Access Compliance Report

Public Rights-of-Way

(Curb Ramps)

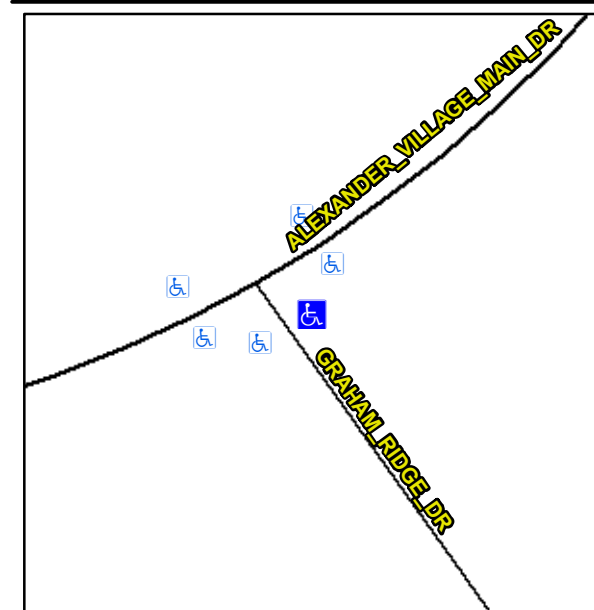
R304.2.2, R304.5.3

Compliance	Description	Data	Compliance	Description	Data
N/A	Ramp Length (in)	102.0	N/A	Grade Break?	N/A
Yes	Ramp Width (in)	67.0	N/A	Grade Break Slope (%)	0.0
No	Ramp Slope (%)	9.1	N/A	Grade Break XSlope (%)	0.0
No	Ramp XSlope (%)	2.1			
N/A	Flare Type LT	N/A	N/A	Flare Type RT	N/A
N/A	Flare Slope LT (%)	N/A	N/A	Flare Slope RT (%)	0.0
N/A	Flare Traversable LT?	N/A	N/A	Flare Traversable RT?	N/A
N/A	Landing Length (in)	0.0	N/A	DWS Provided?	N/A
N/A	Landing Width (in)	0.0	N/A	DWS Contrast?	N/A
N/A	Landing Slope (%)	0.0	N/A	DWS Length (in)	N/A
N/A	Landing X Slope (%)	0.0	N/A	DWS Full Width?	N/A
N/A	Landing Curb? (Y/N)	N/A	N/A	DWS Offset LT (in)	N/A
N/A	Shared Landing?	N/A	N/A	DWS Offset RT (in)	N/A
N/A	Gutter Ponding?	0.0	N/A	Gutter Slope (%)	N/A
N/A	Gutter Lip Ht (in)	0.0	N/A	Gutter X Slope (%)	N/A
N/A	Painted X Walk1?	Yes		Road Slope (%)	0.9
	X Walk 1 Direction	To SW		Road X Slope (%)	1.8
	X Walk 1 Width (in)	105.0		Clear Space?	N/A

Remove & Replace Entire Ramp.
